# Balliemeanoch Pumped Storage Hydro

Further Environmental Information

June 2025

Figure 4.3.1: Modelled flow duration curve for the River Awe

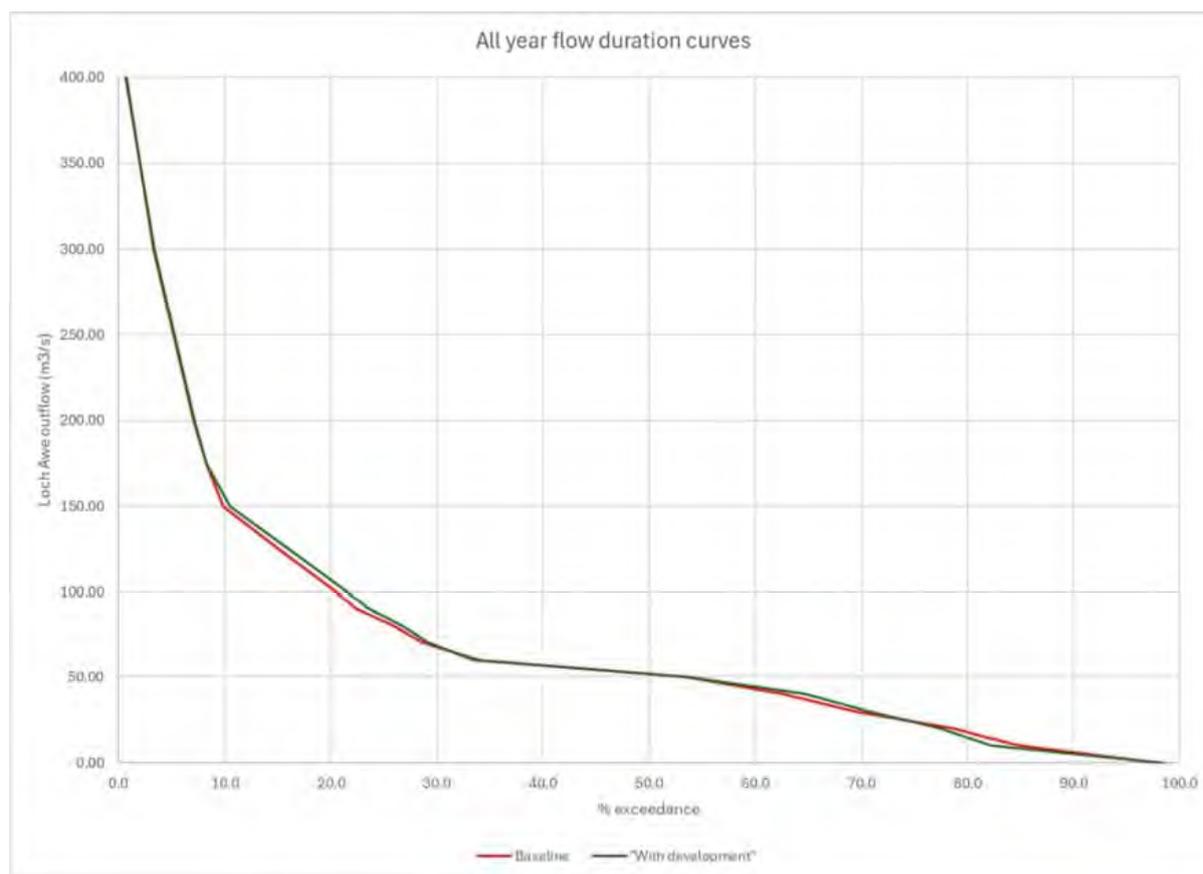
The changes in water level that can result from the operation of the Development is being reduced from 1.2 m to 0.4 due to the revised design. Modelling of the outflow at the Awe Barrage with the operation of the revised Development shows that changes in flow will be negligible (<5%) over the course of the year (Figure 4.3.1). The baseline outflow rating at the barrage is estimated based on the change in volume of the loch and the calculated inflow to determine the total outflow from the loch, but it is uncertain what proportion of outflow involves pumping into Cruachan Headpond, abstraction into the Barrage hydro-electric intake, flow through the fish pass or any other compensation flow arrangement. Given the results of the current modelling approach for the revised scheme, the upstream migration of fish from the River Awe into Loch Awe will not be affected.

BALLIEMEANOCH PSH  
 ZONE 1 REVISED GA  
 2 of 2

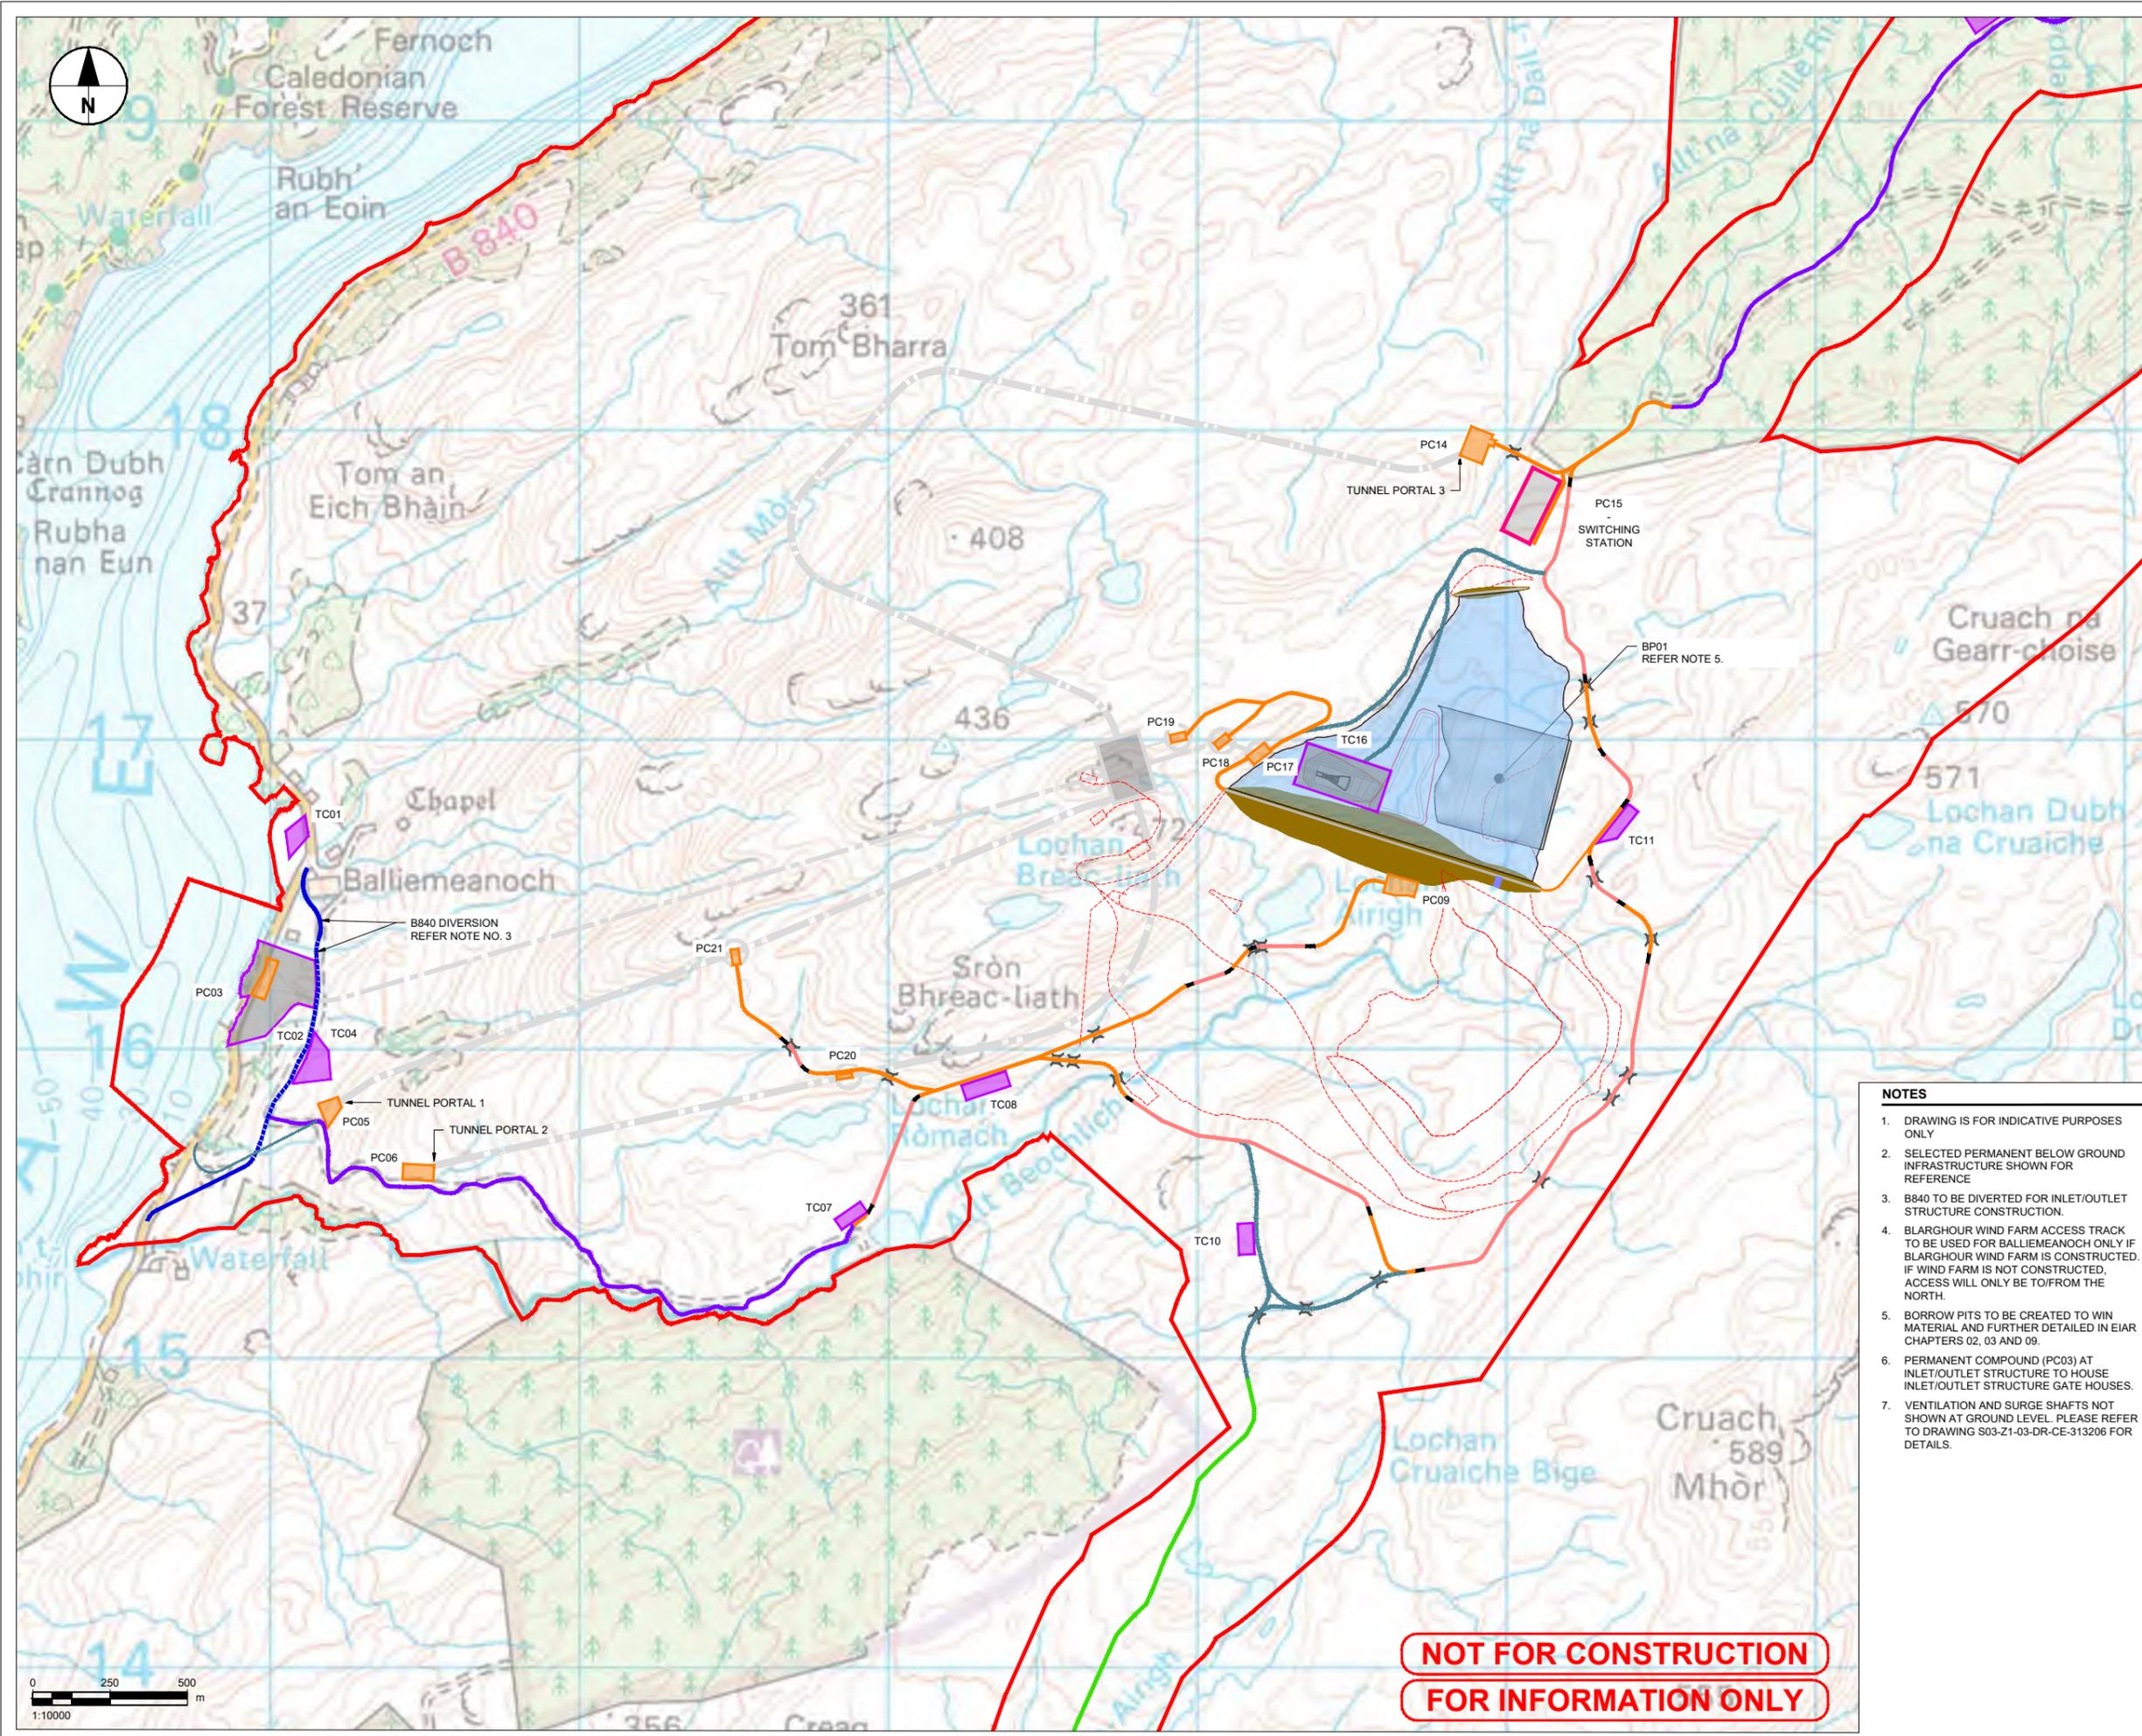
The re-evaluated Headpond has been considered with the same Top Water Level (420 mAOD) and Bottom Water Level (384 mAOD) as set out in the original s36 application. Note, all changes to the Headpond are within the footprint / envelope of the original design submitted for s36 consent, and the description and location of the Development have not changed. The below shows the original design and the revised design, with further figures within **Appendix A Revised Layout**.

Infrastructure ID	'Original' Design Location (National Grid Reference (NGR))	Re-evaluated Location (NGR)	Details
Embankment 1	NN 04110 16014	NN 04540 16687	Embankment 1 has been relocated and realigned, accounting for the topography of the area. Top water levels within the Headpond have been retained at the levels set out in the s36 application, however, the crest level of the dam has been reduced 2 m, from 425 mAOD to 423 mAOD. Due to the rising topography, the maximum elevation above existing ground reduces the height of the embankment from approximately 95 m to approximately 63 m.
Embankment 2	NN 04929 17519	NN 04939 17478	Embankment 2 has been relocated and realigned to take account of the topography. The crest level of the dam has also been reduced from 425 mAOD to 423 mAOD, in alignment with Embankment 1. Accounting for this new arrangement, the maximum elevation above existing ground level has been reduced from approximately 13 m to approximately 9 m.

Headpond Inlet / Outlet Structure	NN 04099 16477	NN 04429 16877	The Headpond Inlet / Outlet Structure has been relocated to sit within the basin of the re-evaluated Headpond. Due to the topography, an inlet trench is required to house the Headpond Inlet / Outlet Structure. The inlet trench measures approximately 240 m x 60 m and has a maximum cut of

A	10.04.2025	DESIGN REVISION POST SUBMISSION
I/R	DATE	DESCRIPTION
